# San Clemente Dam Seismic Safety Project

## Final Supplement to the EIR, No. 2 Old Carmel River Dam Removal

**SCH # 2012071036**

**August 2012**

**Figure 3-3: Old Carmel River Dam Site Plan**

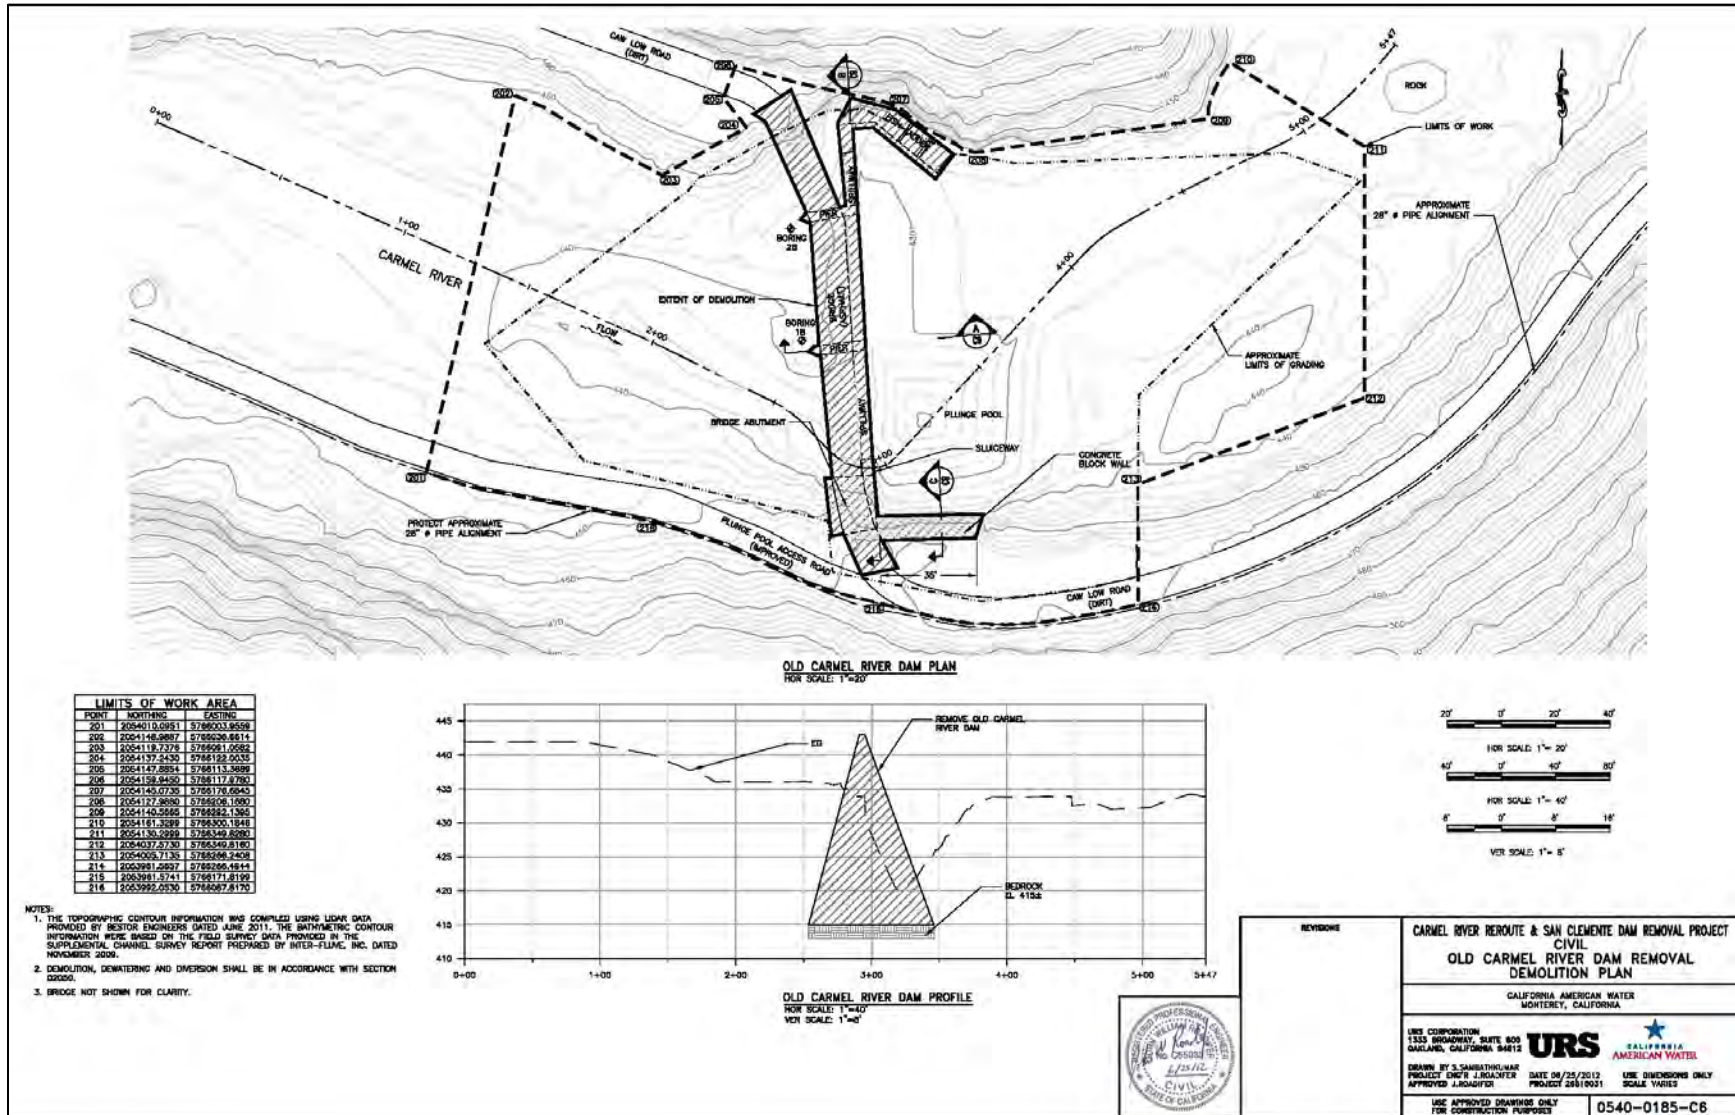
*A figure should be provided showing the OCRD in greater detail than is visible in Figure 3-2. Specifically, the location of the fish ladder, plunge pool, and proximity of the OCRD bridge to the dam should be depicted.*

- A figure should be provided showing the OCRD in greater detail than is visible in Figure 3-2. Specifically, the location of the fish ladder, plunge pool, and proximity of the OCRD bridge to the dam should be depicted.

Figure 3-3: Old Carmel River Dam Site Plan shows these features and has been attached as part of this response and is incorporated into this Final SEIR No. 2

See Figure 3-3: Old Carmel River Dam Site Plan attached to this response and incorporated into this Final SEIR No. 2. The footprint for the removal of OCRD is approximately 1.2 acres.

**Figure 3-4a: OCRD Demolition Sequence (1 of 5)**

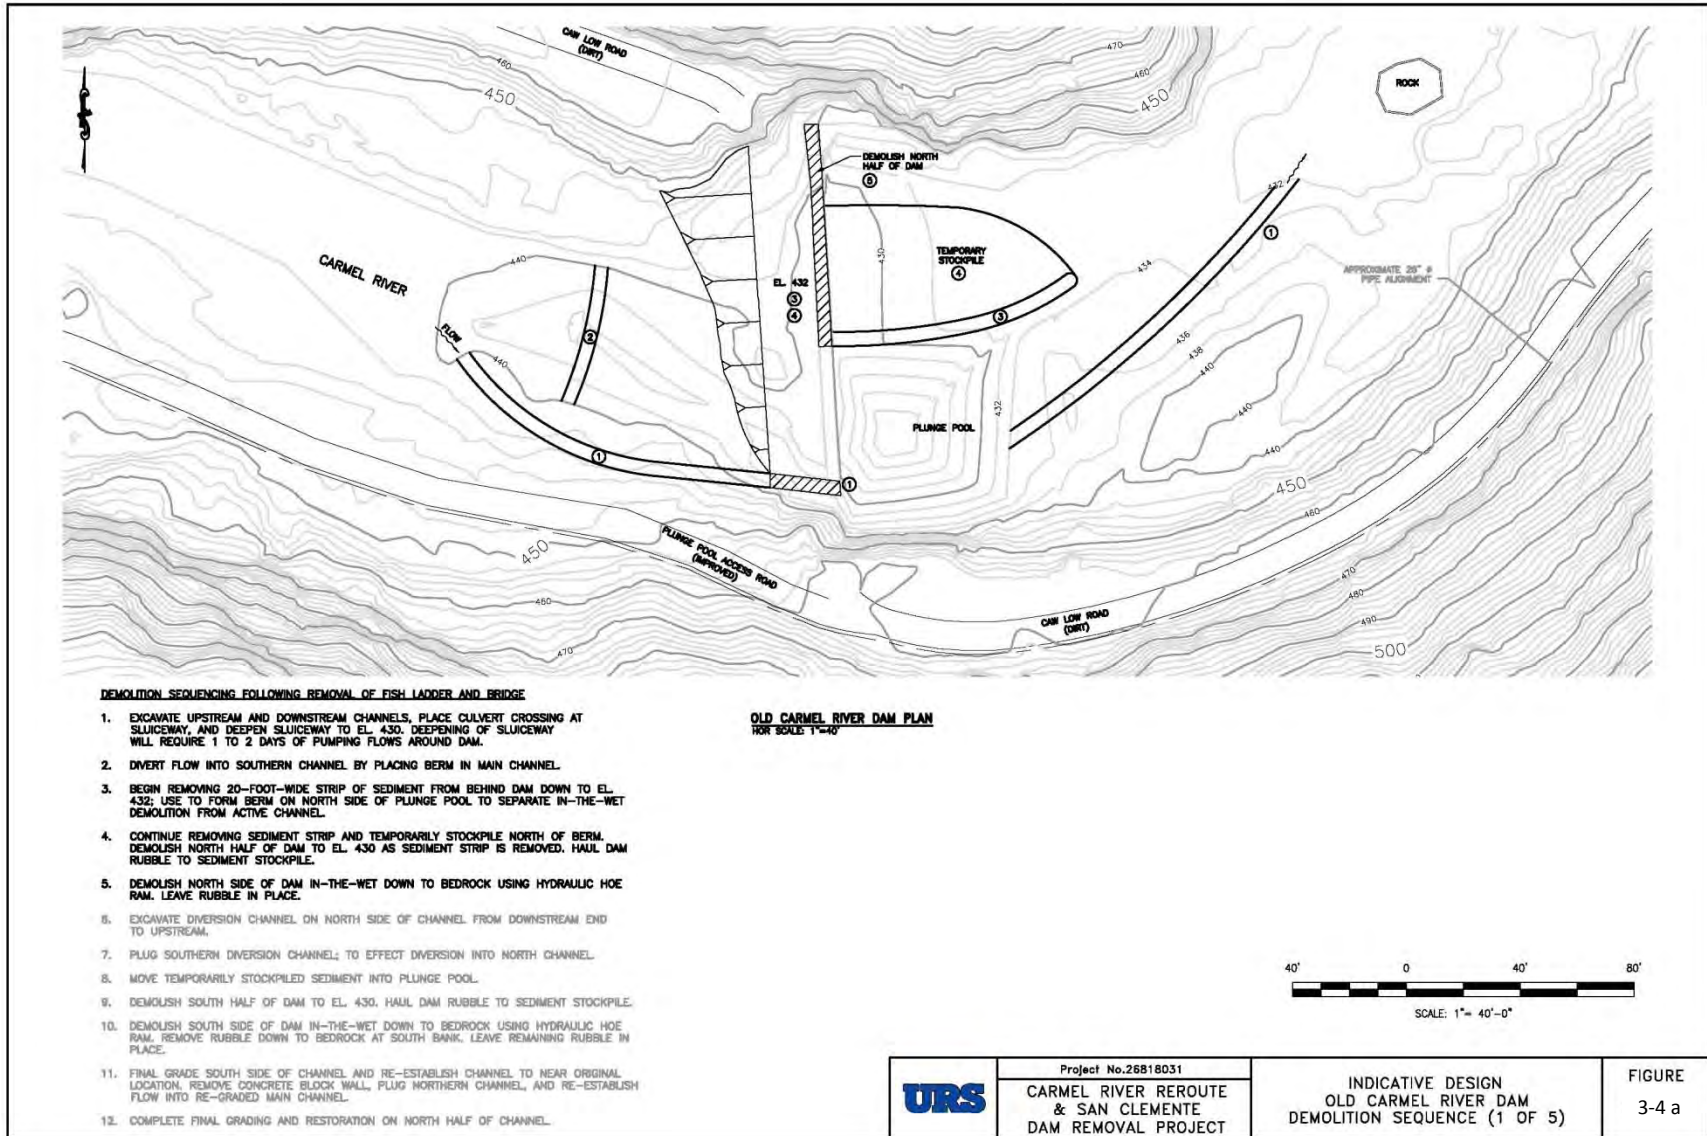
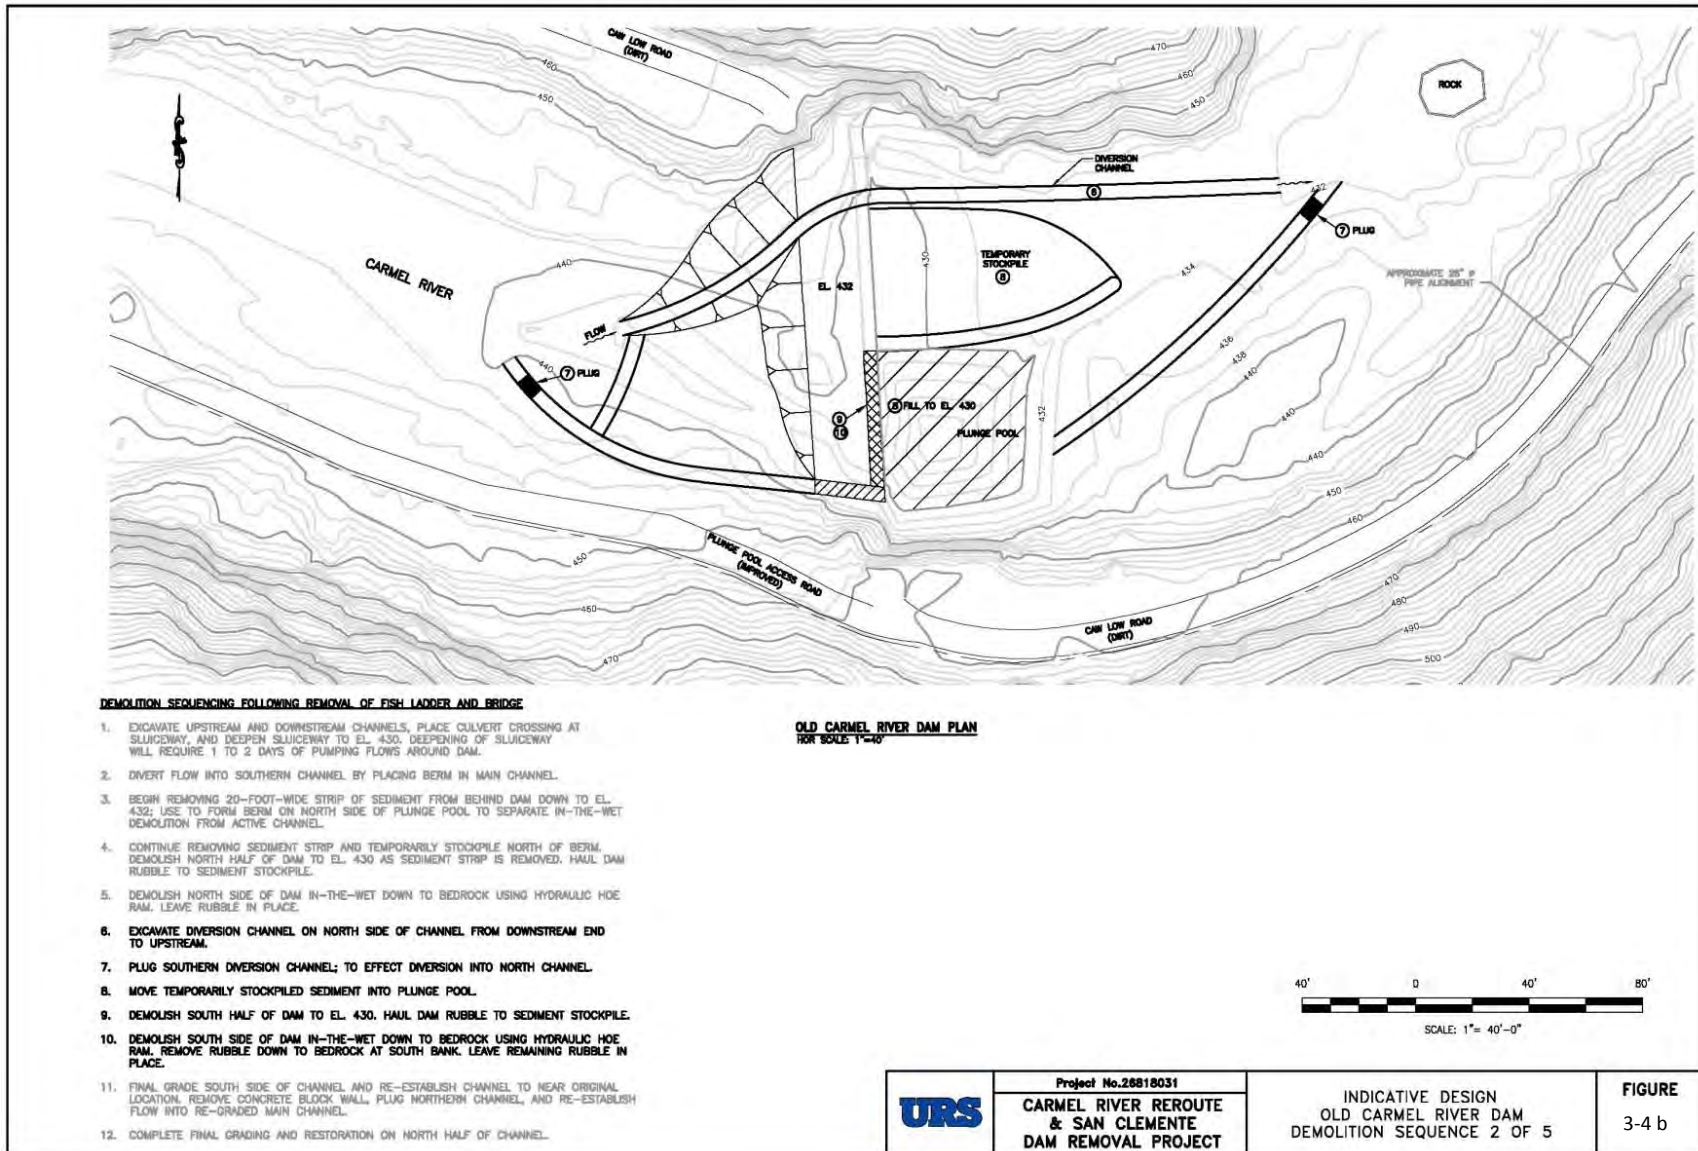
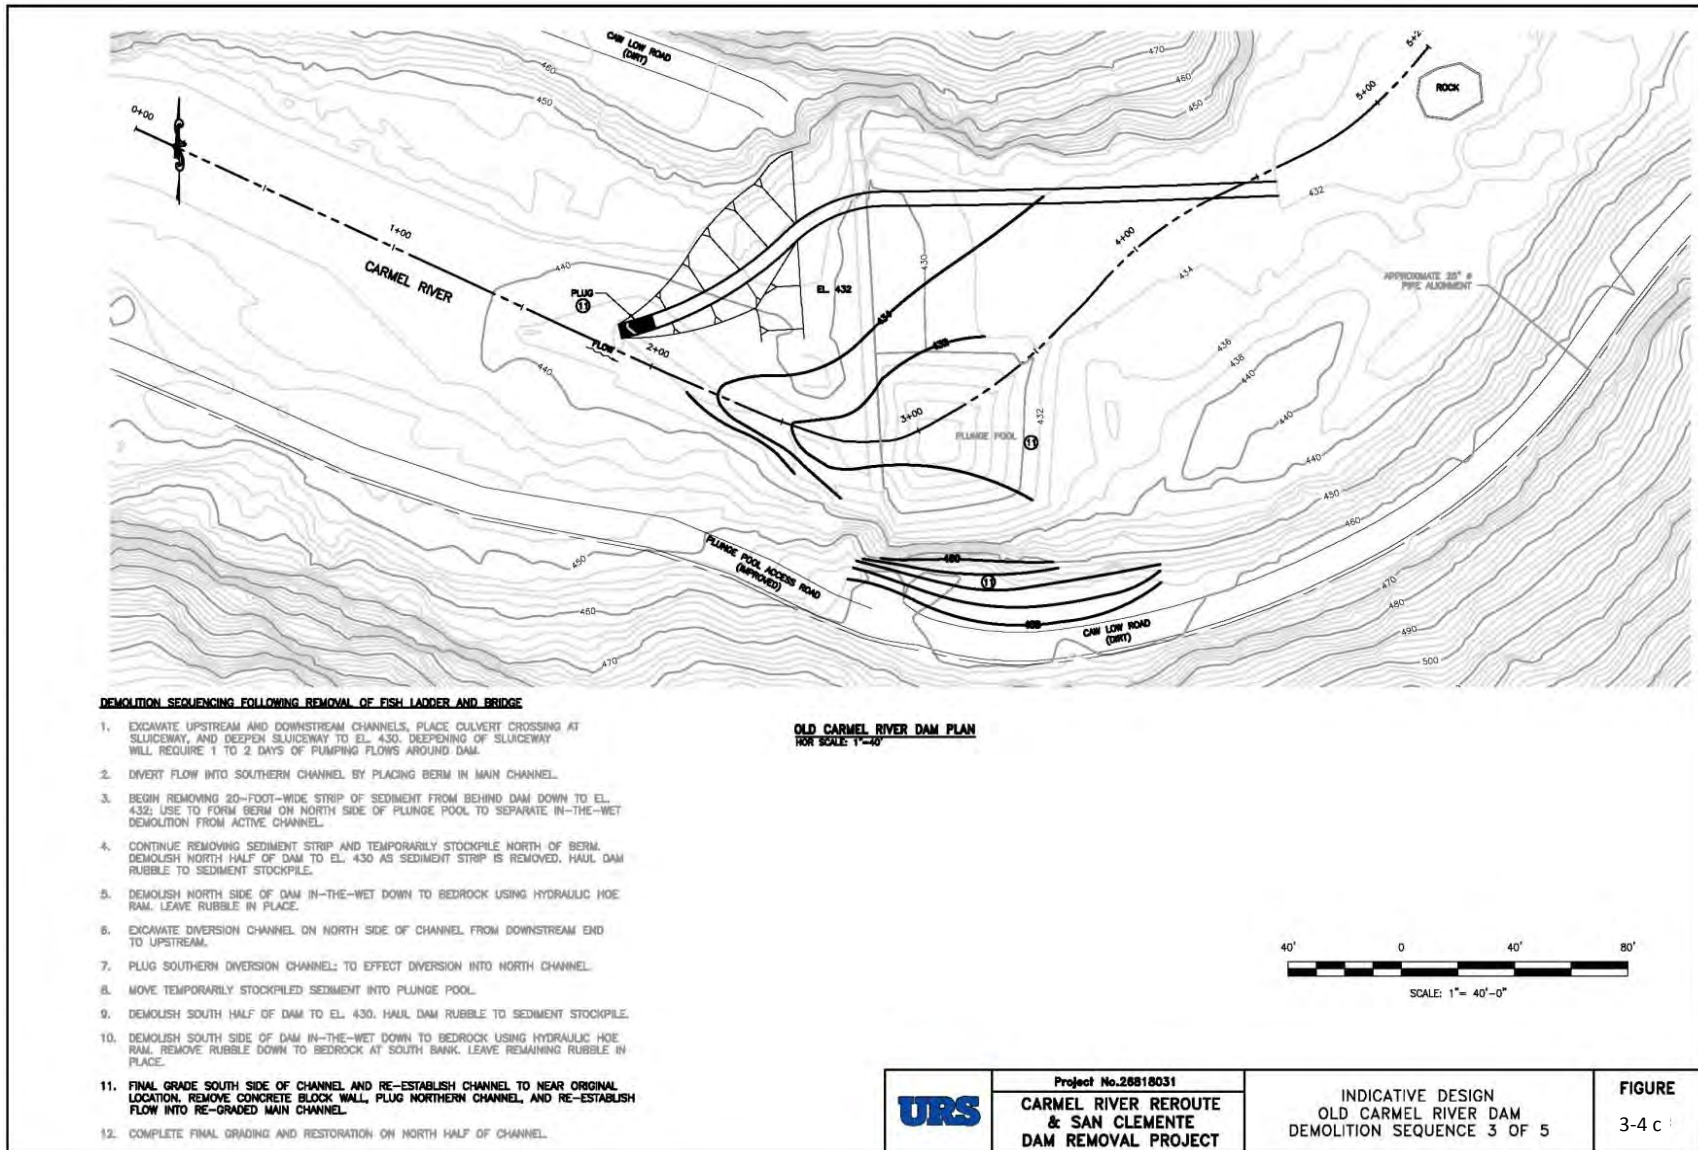
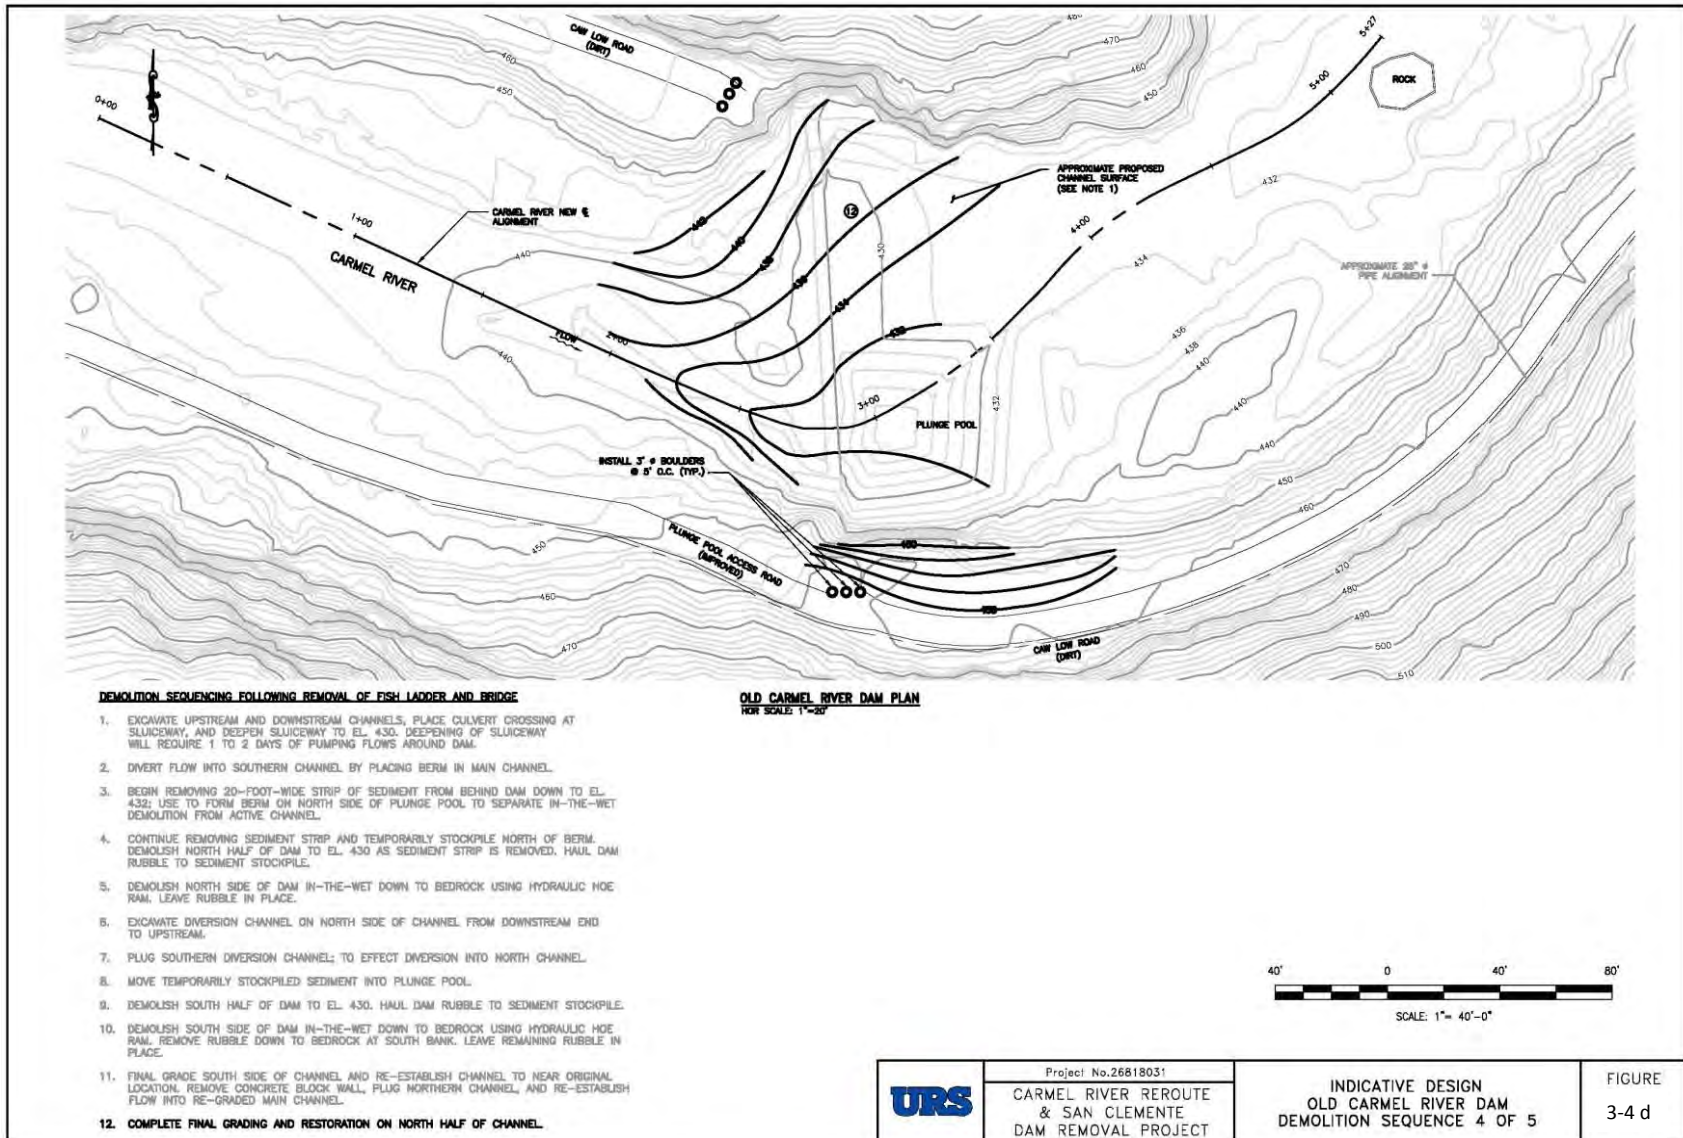
*Page 3-4 of the Second SEIR states that "It is not expected that engineered diversion facilities (e.g., sheet piles, coffer dams, etc.) would be necessary to contain the river flow in its current low flow channel (around the initial demolition work area); however, they may be used if needed." This description is too vague to allow meaningful analysis. The project description should clarify why such diversion facilities are considered unnecessary, and what conditions would warrant their use "if needed." If used, such facilities must be described and analyzed within the Second SEIR.*

Figure 3-4 a-e: Old Carmel River Dam Demolition Sequence has been attached as part of this response and is incorporated into this Final SEIR No. 2.
